For Official Use Only 請勿填寫此欄	Application No. 申請編號	A/YC-PH/1077
	Date Received 收到日期	2025-07-08

1. This Planning Statement is submitted to the Town Planning Board (“the Board”) on behalf of Mr. YIK King Kung Philip (“the Applicant”) in support of the planning application for ‘Proposed Temporary Warehouse (excluding Dangerous Goods Godown) with Ancillary Office and associated Filling of Land for a Period of 3 Years’ (“the Proposed Development”) on Lots 29 (Part), 33 (Part) and 35 (Part) in D.D. 111 and Adjoining Government Land, Pat Heung, Yuen Long (“the Site”) under Section 16 of the Town Planning Ordinance.

We would like to submit a response-to-comment, drainage proposal (Plans 6.1 and 6.2) and hydraulic calculations to respond to the comments from Transport Department, Drainage Services Department and Lands Department.

N.T.S

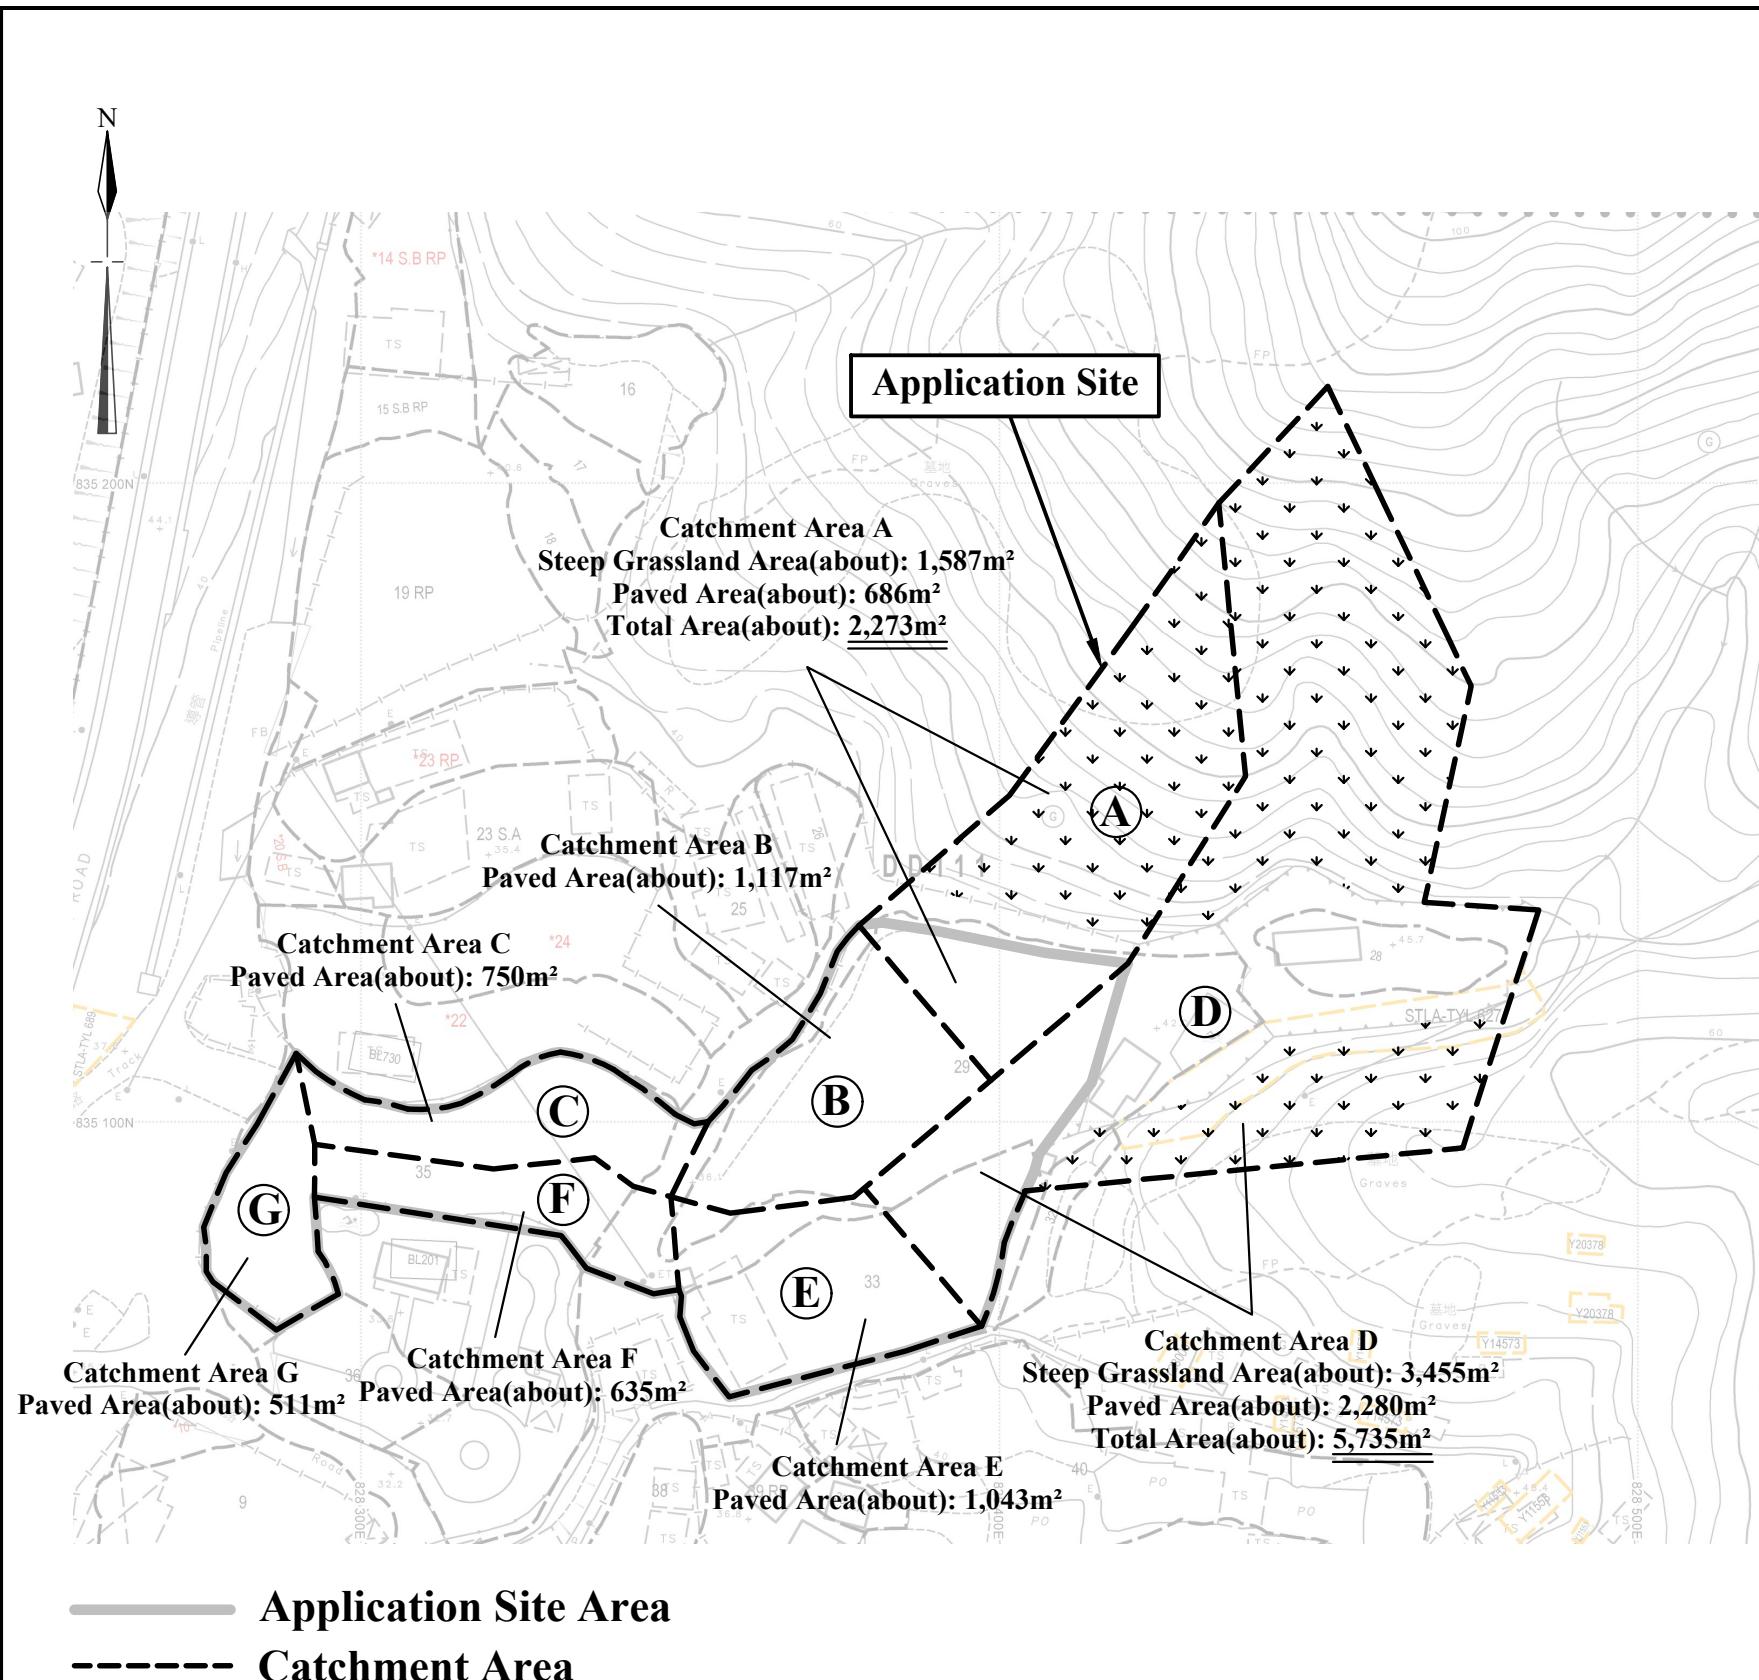
Comments	Responses
2 (a)	<p>The application site is in the vicinity of an existing streamcourse. The applicant shall be required to place all the proposed works 3m away from the top of the bank of the streamcourse. Please show the details in the layout plan. All the proposed works in the vicinity of the streamcourse should not create any adverse drainage impacts, both during and after construction. Proposed flooding mitigation measures if necessary shall be provided at the resources of the applicant to my satisfaction.</p>	<p>We have visited the site. We have not observed the “existing streamcourse” indicated in the plan provided by you. Please refer to photographs showing viewpoints 1.</p> <p>The piece of government land is a local track to structure A and other houses in the north-east of the site.</p> <p>We have not observed any streamcourse in the middle of the piece of land. Please refer to photographs showing viewpoints 2-4.</p> <p>However, to the south side of the site at viewpoint 5, we observe a local ditch about 2m wide.</p> <p>We confirm that all the proposed works will be placed 3m away from the top of the bank of the existing local ditch outside the site at the south.</p> <p>All the proposed works in the vicinity of the existing local ditch would not create any adverse drainage impacts, both during and after construction.</p> <p>Proposed flooding mitigation measures, if necessary, will be provided at the resources of the applicant.</p>

2 (b)	<p>According to the RtC 2, the existing streamcourse/channel on government land within the application site will be preserved and maintained. Please elaborate the details, in particular, the crossing details above the existing streamcourse/channel should be included in the submission for our comment and consideration. Please note that proposal for concealing of the existing streamcourse/channel will not be considered.</p>	<p>Please refer to comment 2(a) above.</p> <p>We would like to clarify that the applicant has not concealed any existing streamcourse/channel on government land. No existing streamcourse/channel is observed on government land within the site.</p>

Comments	Responses
2 (c)	Please make reference to paragraph 6 of DSD Technical Note No.1 for sizing of the drainage channel.	The calculations are worked according to DSD Stormwater Drainage Manual. The sizing of the drainage channels is adequate to collect the surface runoff from the catchment area.
2 (d)	Length of u-channel L_c of 78.3m is adopted for calculating the u-channel size for Area A ($3,389 \text{ m}^2$). Please revise the calculation by dividing the u-channel length in two sections, with section one at the northern side and the section two at the North-western for calculation of the u-channel size for Area A.	Please refer to updated hydraulic calculations. The calculation of the u-channel size for Area A is divided into two sections.
2 (e)	Please refer to (d) above to revise the calculation of u-channel size for Area C ($6,778 \text{ m}^2$).	Please refer to updated hydraulic calculations. The calculation of the u-channel size for Area C is divided into two sections.

Map A

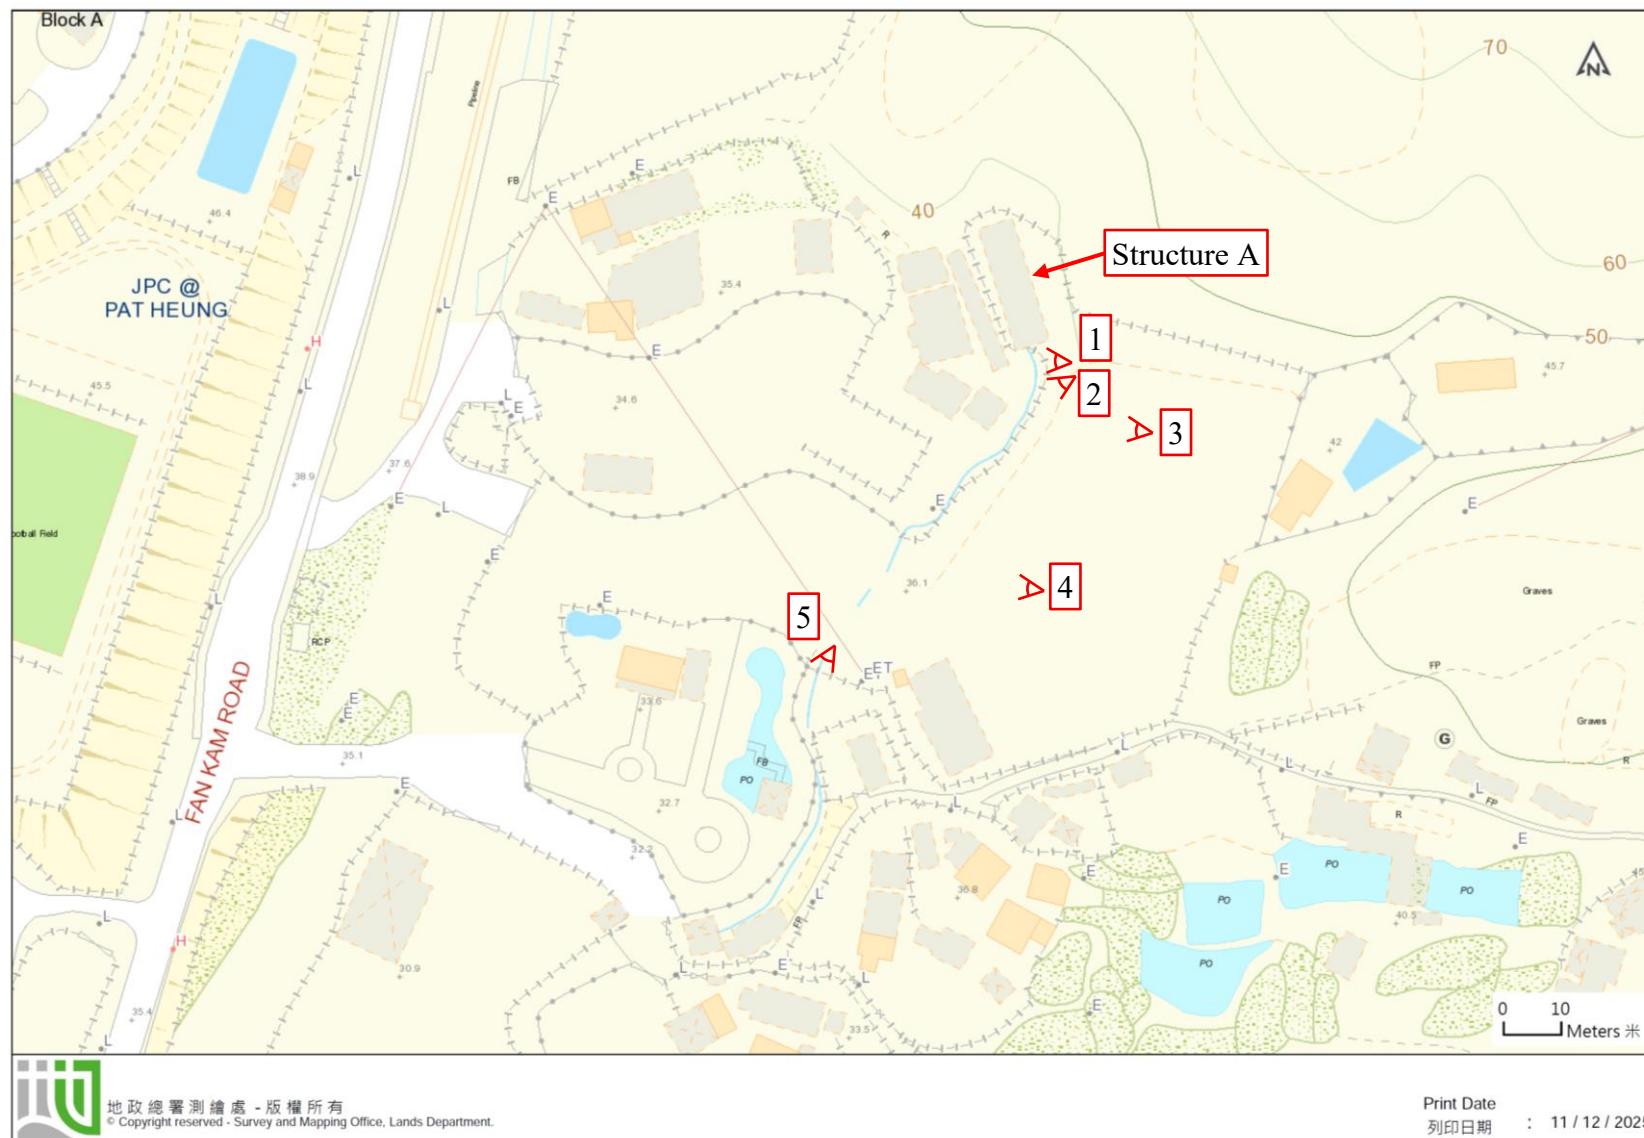
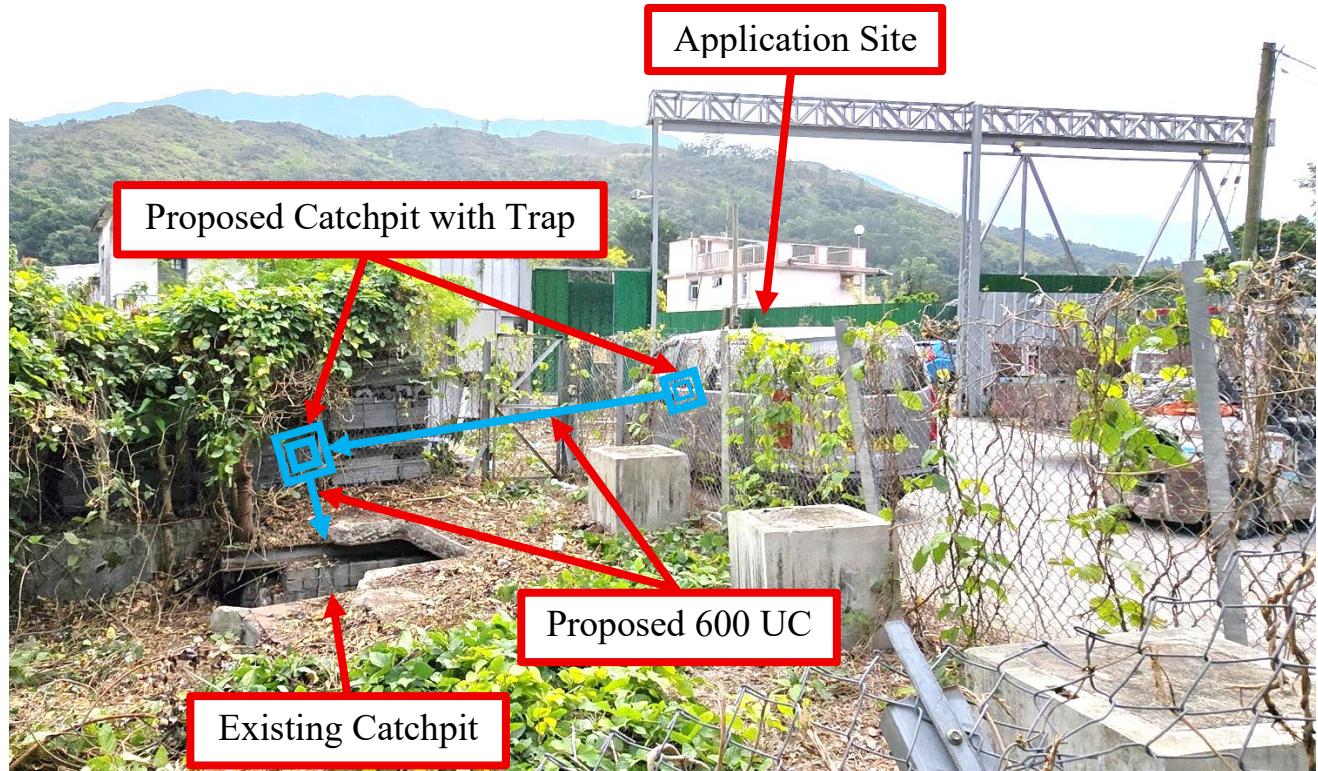
Comments	Responses
i. It is noted that the site area is 5285m ² and the ground to the north of the application site is generally higher. Since the overland flow from the adjacent lands shall be probably intercepted, external catchment shall be considered in the calculation (i.e. Lots 22, 24, 25 and 26, etc. in D.D. 111). Please also make reference to the latest Technical Note No. 1 issued by DSD for more details in preparing the drainage proposal. Please upgrade all drainage facilities size accordingly.	<p>The ground level of the ground to the north is +34.6mPD as shown in Plan 6.1b. The ground level of the western side of the application site is +36.5mPD. Thus, the ground to the north of the application site is lower than the application site.</p> <p>The U-channels within the site are upgraded to 600mm. Please refer to Plan 6.1b.</p>
ii. Referring to R-to-C, please advise whether any section of the said local ditch is within the application site. If affirmative, please ensure that the existing local ditch and the relevant discharge connection(s) should be maintained due to the proposed development. Please also provide adequate measures and drainage facilities to intercept their flow properly. Please indicate the above on the drainage plan for reference.	No section of the said local ditch is within the application site. Please refer to attached site photographs and Plan 6.1b for the viewpoints of the photographs.

Comments	Responses
v.	Please indicate clearly the full alignment of the discharge path from the application site all the way down to the ultimate discharge point (e.g. a well-established stream course/public drainage system).	Please refer to attached photographs.
vi.	The existing 500 mm u-channel, to which the proposed to discharge the stormwater from the subject site was not maintained by this office. Please resolve any conflict/disagreement arisen for discharging the runoff from the application site(s) to the proposed discharge point(s). Moreover, please ensure that this drainage system and the existing downstream drains/channels/streams have adequate capacity to convey the additional runoff from the application site(s). Regular maintenance should be carried out by the applicant(s) to avoid blockage of the system.	Noted.
vii.	Further to (vi) above, since there is no record of the said discharge path, please provide site photos to demonstrate its presence and existing condition.	The discharge path is updated to discharge to an existing catchpit where there are 2 nos. of 1m underground pipe. Please refer to Plan 6.1b and viewpoint photographs 6 and 7.
